QUAD 22 CONTROL UNIT CIRCUIT DIAGRAM

Amendment December, 1959

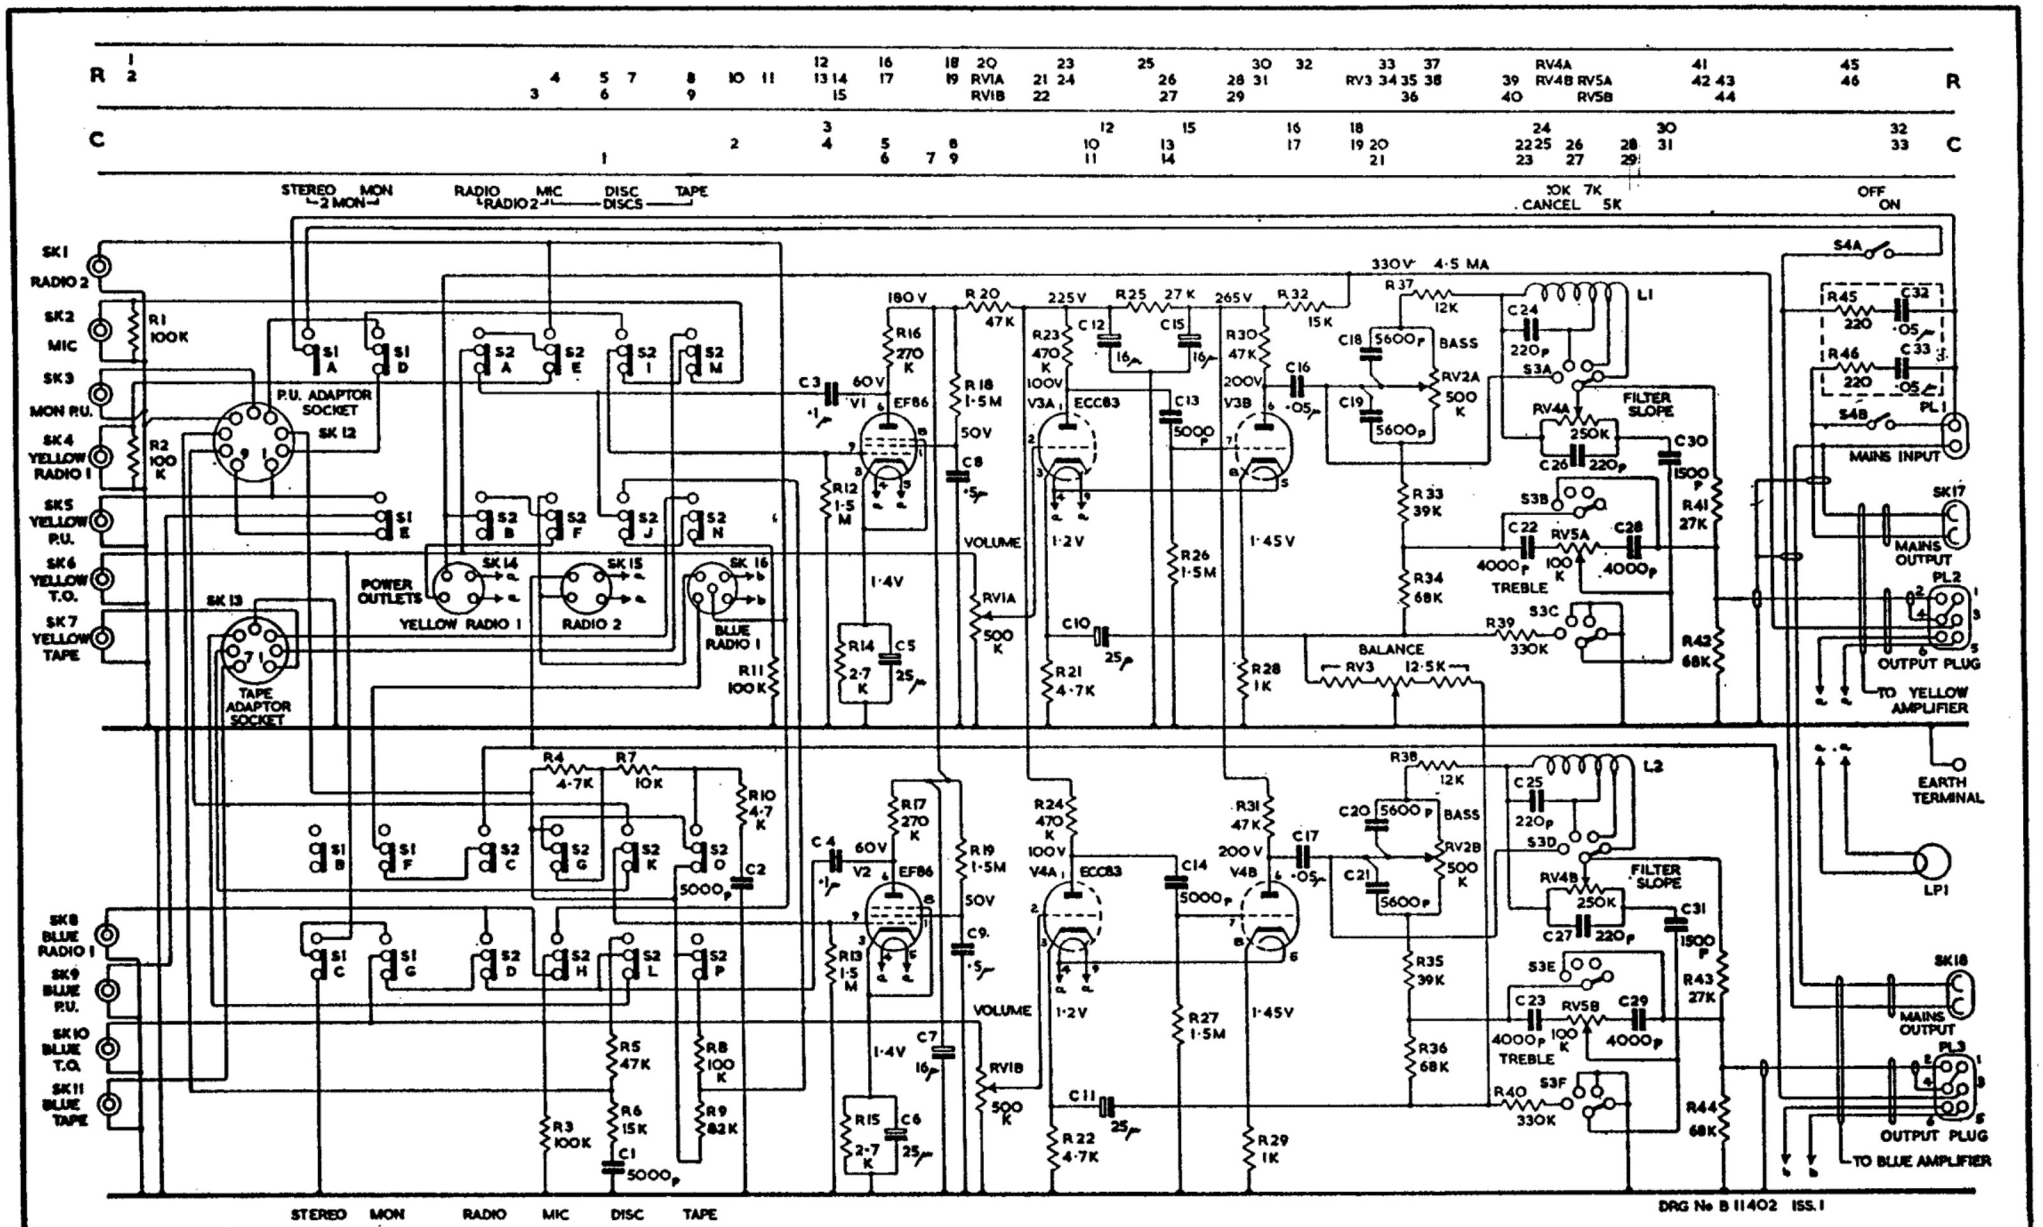
C 13, C 14 } now 820 pF

C 16, C 17 } now .1 uF

C 34, C 35 } added .02 uF in series with volume control.
